0060 Canyon Fuel Company, LLC  
Dugout Canyon Mine  
P.O. Box 1029  
Wellington, Utah 84542

RE: Submittal of As Built Drawings and Clean Copies for Sloped Road Sheet Flow Design  
TASK ID # 2225, Dugout Canyon Mine, Canyon Fuel Company, LLC, C/007/039, Carbon  
County, Utah

**Title:** As-Built Drawings and Clean Copies for Sloped Road Sheet Flow Design - Task ID# 2225

Sloped Road "Sheet Flow" Design

FIGURE 1. RE-GRADING ROAD

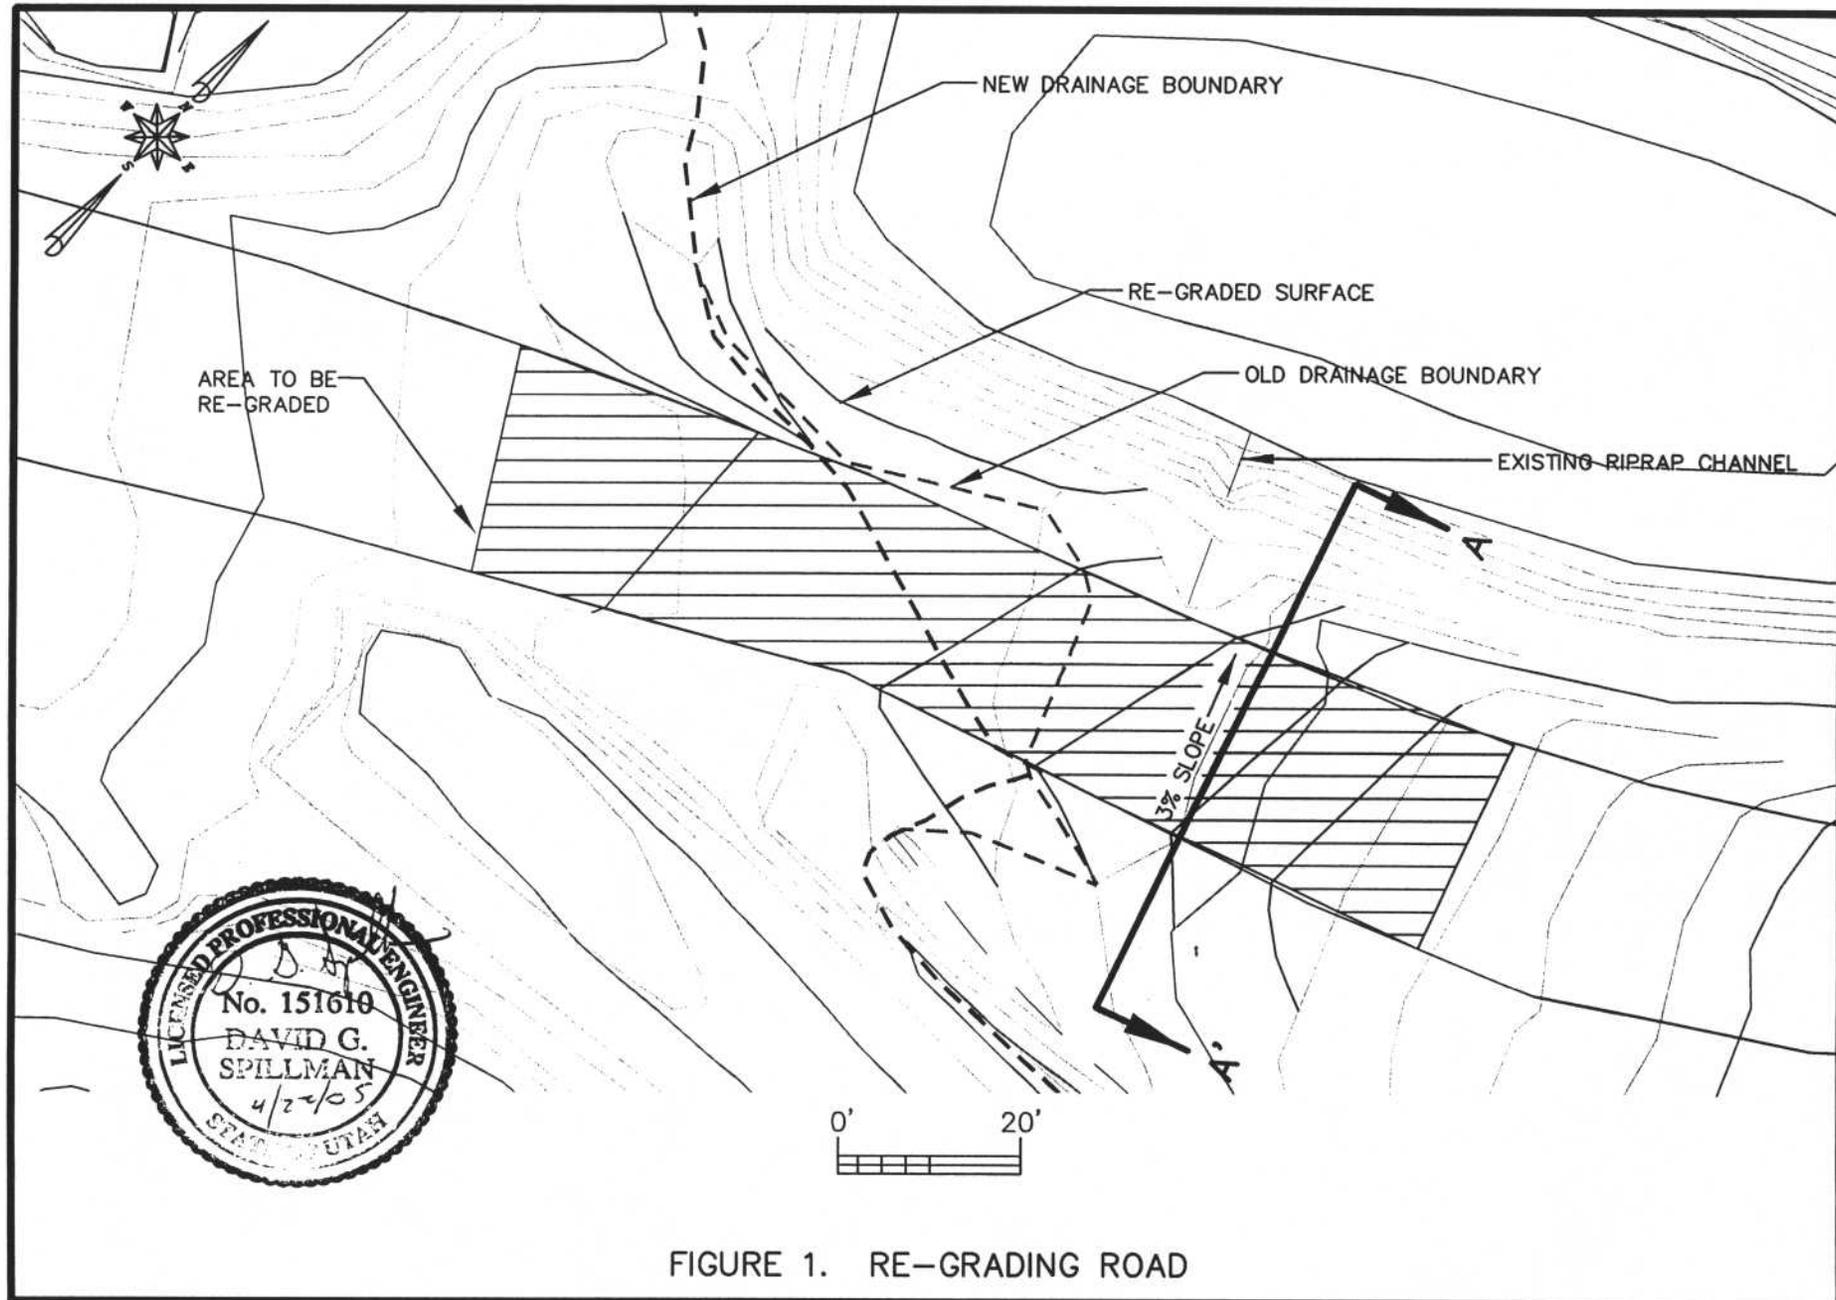
The Dugout Canyon Mine proposes to replace the swale road crossing discussed in Attachment B to Appendix 7-9 with a road sloping toward the sediment pond. The current road swale is a safety concern and damages the suspension system of the coal haul trucks. To ensure that runoff from the road and adjacent areas that currently report to the sediment pond still reports to the sediment pond, approximately 120 feet of roadway will be rebuilt to slope at 3% towards the pond. Figure 1 in Attachment C to Appendix 7-9 shows the area to be modified as well as the current and proposed drainage boundary. As can be seen on the figure the proposed regraded road section will drain just slightly more of the road to the sediment pond than the current swale.

FIGURE 2. ROAD CROSS-SECTION

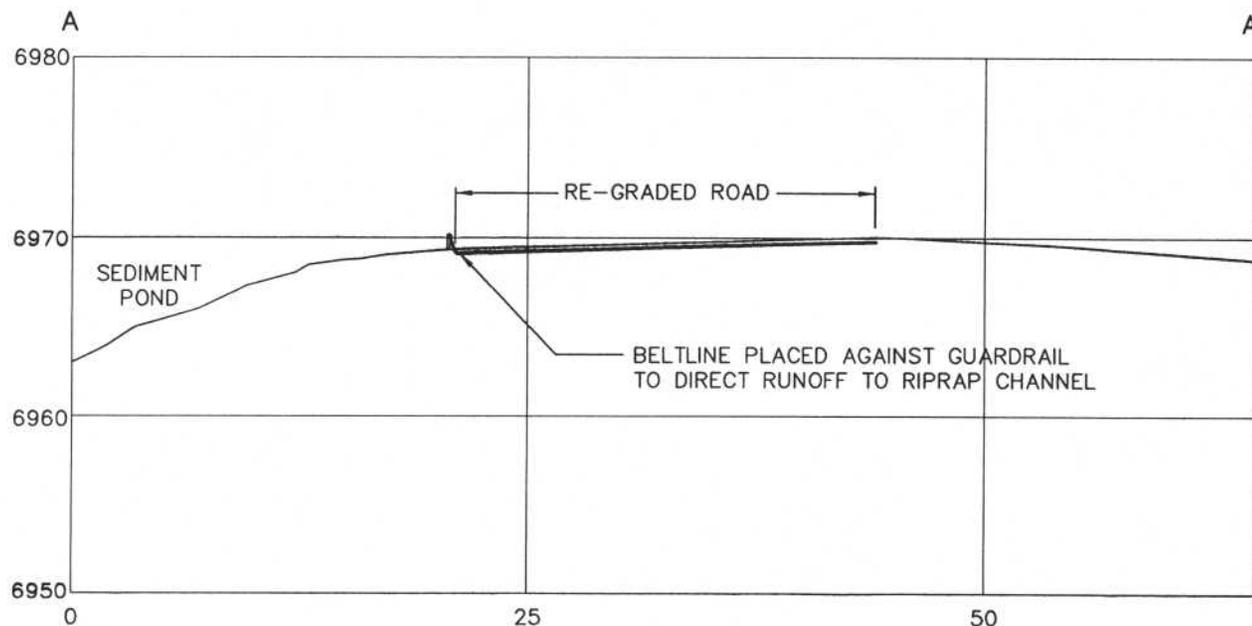
Figure 2 in Attachment C to Appendix 7-9 shows a typical cross-section. The cross-section shows the road sloping at 3% towards the pond and a section of conveyor belting placed against the guardrail to direct road runoff to the existing riprap channel and sediment pond. Please note that a significant portion of the existing road (northeast of the swale) currently is sloped towards the sedimentation pond. The conveyor belting against the guardrail is an existing feature that functions well in directing road drainage towards the riprap channel. This conveyor belting feature will remain intact helping to insure that the road runoff will enter the sediment pond through the riprap channel. A very small amount of road runoff below this point will sheet flow off the road towards the sediment pond and will not require an additional ditch or culvert.
